Office Action Summary

09/688,989

TSUNASHIMA ET AL.

Response to Amendment

FIG. 3(d)

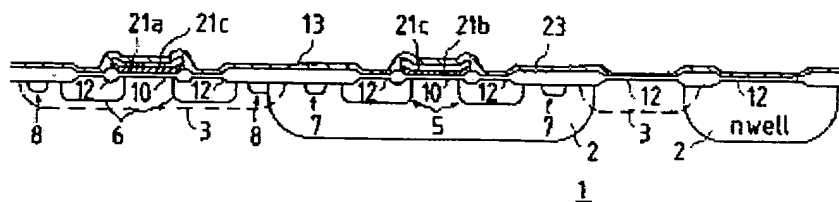
Applicants contend that Tada does not disclose/ suggest that the sidewalls of the gate electrodes are connected.

However Tada in Figure 3D shows element (21) connecting gate electrodes sidewalls 13 a and b. (reproduced below).

Therefore contrary to applicants' contention all of the presently recited limitations of the claims, including sidewalls of the gate electrodes 13 a and 13 b are connected by element (polysilicon layers) 21 a and 21 b (col. 8 lines 1-11) is taught , (and to the extent understood " a sidewall of the first gate electrode at one end of a channel direction is connected to a side wall of said gate electrode at one end of the channel direction") by Kume and Tada and therefore prima facie obviousness has been established.
